The Columbia Architectural Design Review Team will meet on Tuesday, December 12, 2023 at 9:00 AM in Conference Room A on the basement level of City Hall, 700 N. Garden Street to consider the following:

Request from Greg Gamble for new construction façade approval within a Planned Unit Development at 400 Bear Creek Pike.

ART 23-0416

PROJECT DESCRIPTION: Façade Design Approval for Single-Family Homes, Townhomes, Amenity Ares, and Daycare Facility

TOWNHOMES

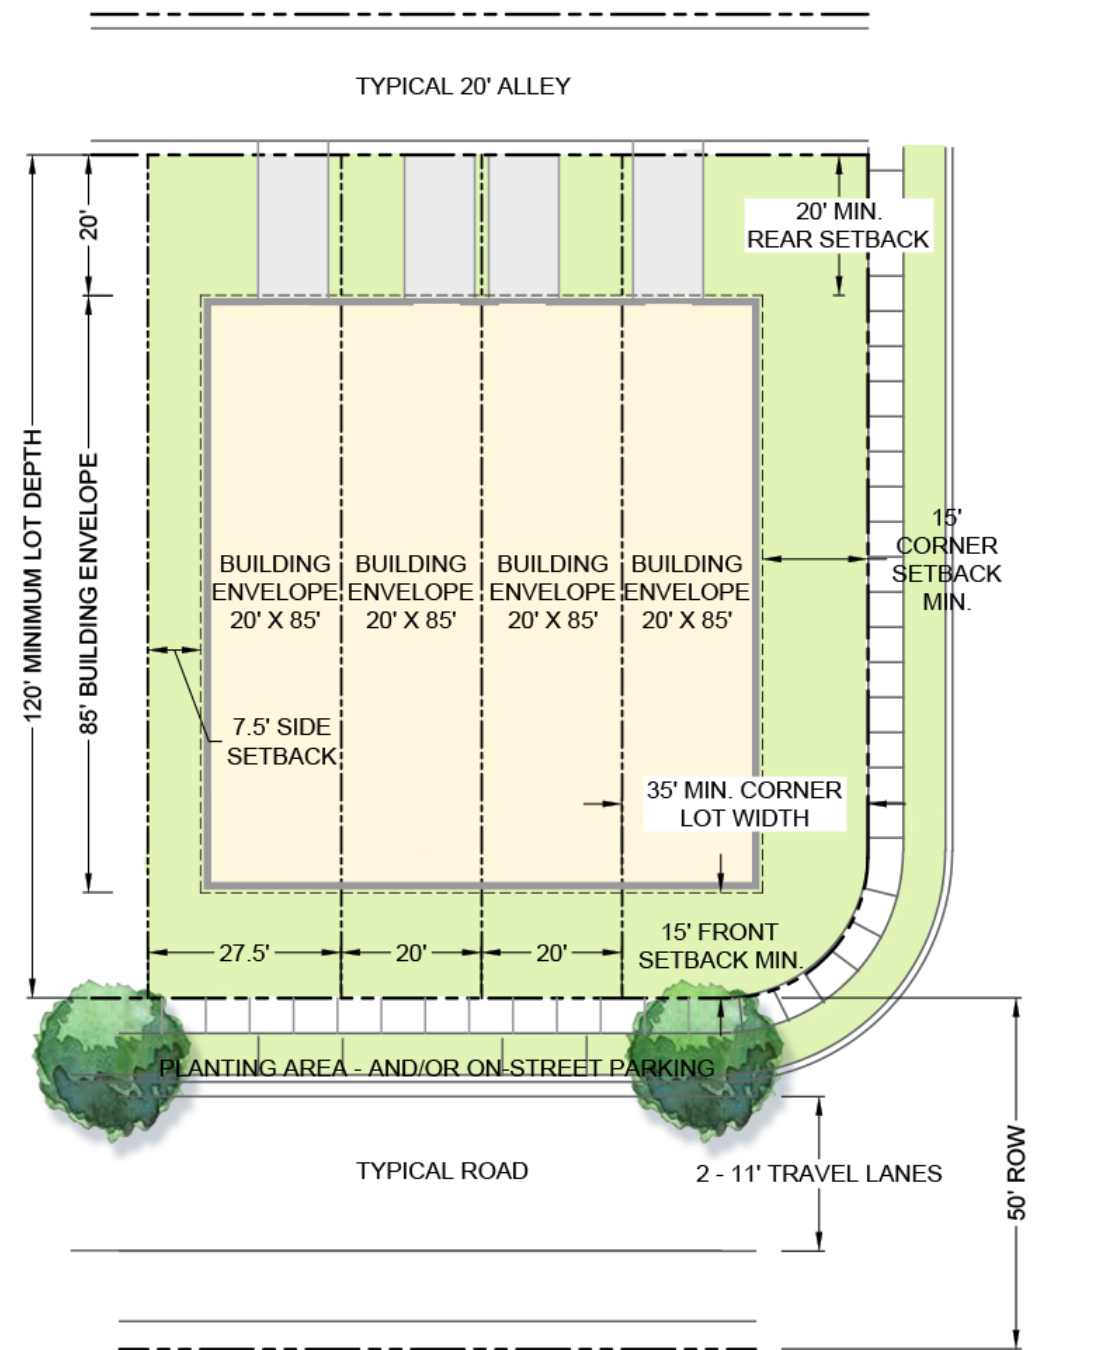
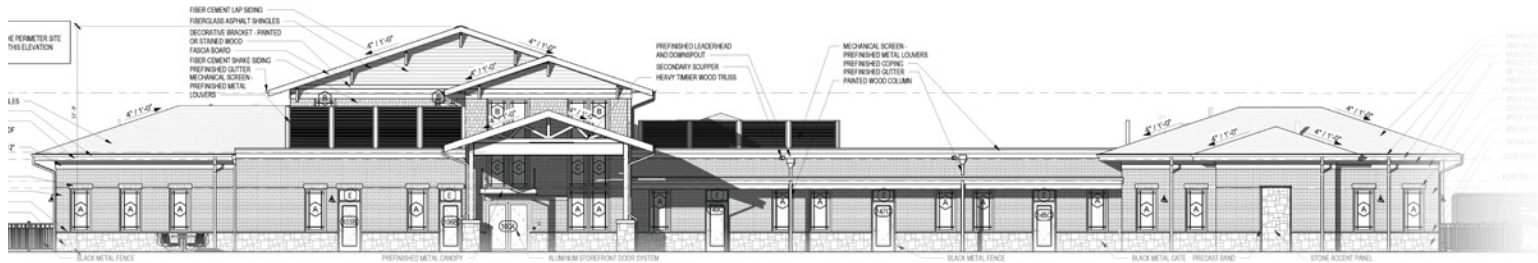
(PUD R) District Standards : Townhomes		
Design Standards:	Required	Proposed
Vertical Composition:	Identifiable Base, Middle, & Cap	Some elements of the townhome design do not indicate a defined base
Finished Floor Elevation:	Min 18 inches above finished grade	Details of the FFE were not given.
Façade Position & Façade Articulation:	Main entrance at façade & position parallel to frontage line	All townhomes enfront a street section
Façade Openings:	20 ft. or less spacing for windows/doors	All windows appear to be 20 ft or less with no blank facades.
Façade Glazing:	20-60 %	Glazing appears to be at least 20 percent.
Window Shape:	Square or vertical proportions	All windows are square or vertical proportioned.
Window Alignment:	Upper floor windows and other features must be aligned with those of first floor	All windows align with those on the first floor.
Window Types:	Single-hung, double-hung, casement	All windows adhere to the window type standards as described.

Window Glazing Material:	Clear	All windows proposed are clear glass.
Window Trim in 1st Layer:	Min 4 in. trim with sill and top plate/ soldier course above lintel and rowlock course below sill	Elevations appear to consist of window trim details and rowlock course below window sills and soldier course above windows for brick elevations.
Shutters:	Functional to cover half of window width/ shutter dogs	Details were not given on functionality of shutters including details of shutter dogs. An element on one elevation indicates shutters being used in non-functional way that does not cover a window but rather used as a decorative element.
Façade Window Sill Height:	5 ft. min above grade	Details were not given on façade window sill height 5' min above grade.
Porch Frontages:	Min. 6ft. clear depth, excluding rails, pillars, columns	Details were not given for minimum 6 ft. depth on townhome elevations that indicate a porch.

Façade Variety:	No façade may exist more than once on a block face or within view of same façade	A detail has been provided to indicate variety of facades to ensure that a façade is not present more than once on a block face or in view of the same façade for single-family homes. This detail was not provided for the townhome section but can apply.
Roof Type & Pitch:	Hip/ Gable	Hip & gable elements are provided for roof type and pitch.
Primary Building Materials:	Brick, Fiber Cement Board, Wood	Brick and fiber cement board have been indicated as the primary materials for townhomes.
Foundation Cladding:	Brick or Natural Stone	Some elevations that are fiber cement board do not indicate a foundation cladding of brick or natural stone.
Porch Pier/ Chimney Cladding:	Brick or Natural Stone & any space under porch concealed by lattice/ brick or natural stone for chimney	Some elevations do not indicate a porch pier that is clad in brick or natural stone.

Garage Location:	3 rd Layer (20 ft. behind primary façade)	All townhomes are proposed to be rear loaded with garages being located in the 3 rd layer in adhered to this design standard.
Garage Design:	Min. interior dimensions 10 X 20 per vehicle Parking Space. Garage door must have ornamental lighting	Details were not given on interior garage dimensions. In addition, details shall be given that garage door width does not exceed 33% of

DAYCARE ELEVATIONS

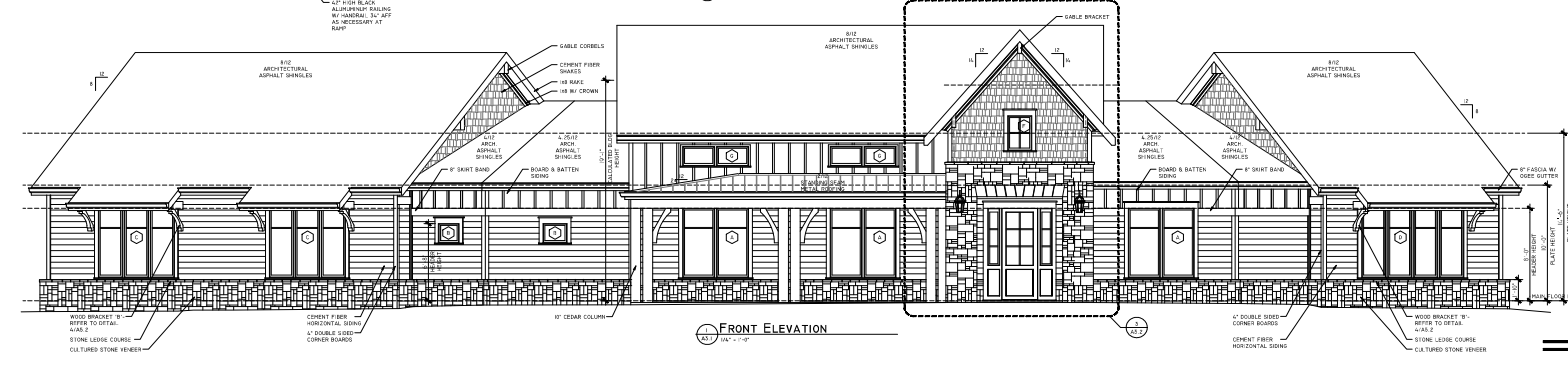
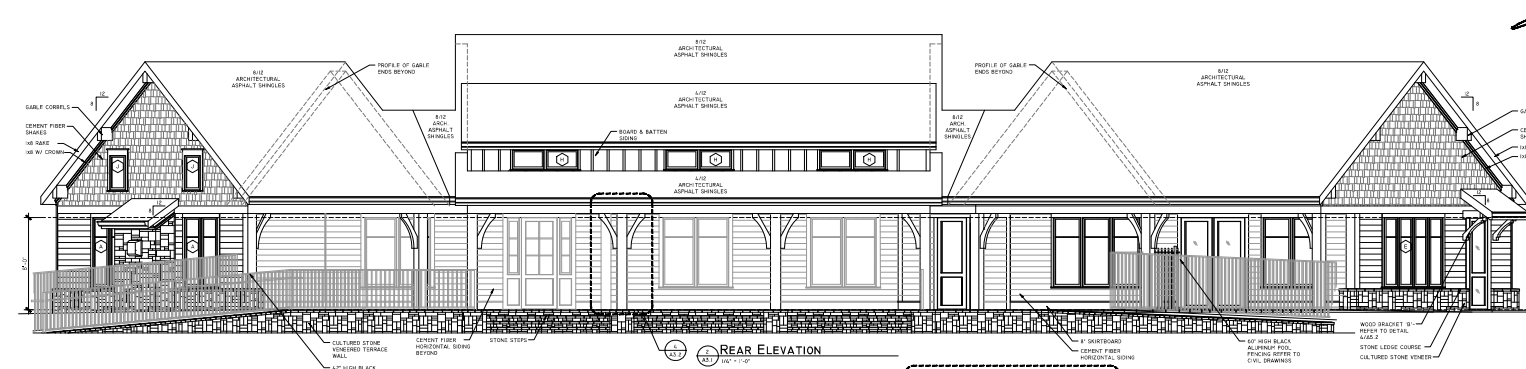
(PUD R) District Standards : Day Care Facility		
Design Standards:	Required	Proposed
Vertical Composition:	Identifiable Base, Middle, & Cap	All structure indicates a defined base, middle, and cap.
Finished Floor Elevation:	Min 18 inches above finished grade	Details of the FFE were not given
Façade Position & Façade Articulation:	Main entrance at façade & position parallel to frontage line	The proposed daycare enfronts a proposed street section with entrance.
Façade Openings:	20 ft. or less spacing for windows/doors	All windows appear to be 20 ft or less with no blank facades
Façade Glazing:	20-60 % (70% glazing for shopfront elevation)	Shopfront elevation does not indicate 70 percent glazing requirement.
Window Shape:	Square or vertical proportions	All windows are square or vertical proportioned.
Window Alignment:	Upper floor windows and other features must be aligned with those of first floor	All windows align with those on the first floor.

Window Types:	Single-hung, double-hung, casement except in shopfront or galley	Windows appear to be fixed glass at all elevations
Window Glazing Material:	Clear	All windows proposed are clear glass.
Window Trim in 1st Layer:	Min 4 in. trim with sill and top plate/ soldier course above lintel and rowlock course below sill	Elevations appear to consist of window trim details and rowlock course below window sills and soldier course above windows for brick elevations.
Shutters:	Functional to cover half of window width/ shutter dogs	N/A
Façade Window Sill Height:	5 ft. min above grade	Details were not given on façade window sill height 5' min above grade.

Porch Frontages:	Min. 6ft. clear depth, excluding rails, pillars, columns	N/A
Façade Variety:	No façade may exist more than once on a block face or within view of same façade	This use proposed is a single site use that consist of one façade.
Roof Type & Pitch:	Hip/ Gable	Roof type & pitch proposed is hip & gable
Primary Building Materials:	Brick, Fiber Cement Board, Wood	Elevations consists of a primary façade material of brick with a stone base including fiber cement board
Foundation Cladding:	Brick or Natural Stone	Foundation cladding indicated is stone
Porch Pier/ Chimney Cladding:	Brick or Natural Stone & any space under porch concealed by lattice/ brick or natural stone for chimney	Porch piers indicate a stone base
Building Height:	2 Stories min- 4 stories max	2 stories
